Service Information

VRZ SERVICE MANUAL REVISION

One of the part numbers in the 'VRZ' service manual (Publication No. EE14E-11163) has been corrected.

Page 41 ('5 GEAR REASSEMBLY' section)

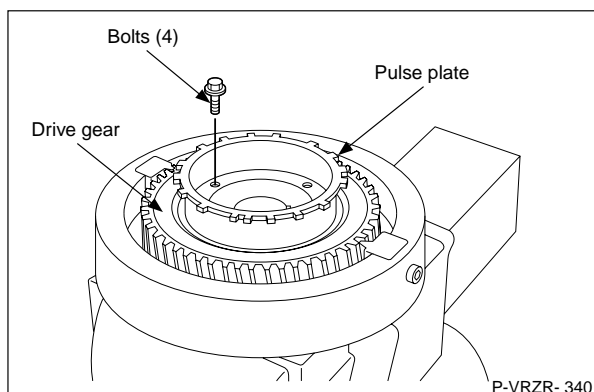
The Mitsubishi part number for the bolt 149917-1400 has been incorrectly inputted.

- Location of corrected part number: Refer to 'Correction' in the figure below.
- Correct part number: **RBJP part number** 149917-1400 **Mitsubishi part number (corrected)** MH001566

Part name	Part no. (Mitsubishi part no.)	Remarks
Bolts	149917-1400 (MH001566)	4; not reusable

Correction
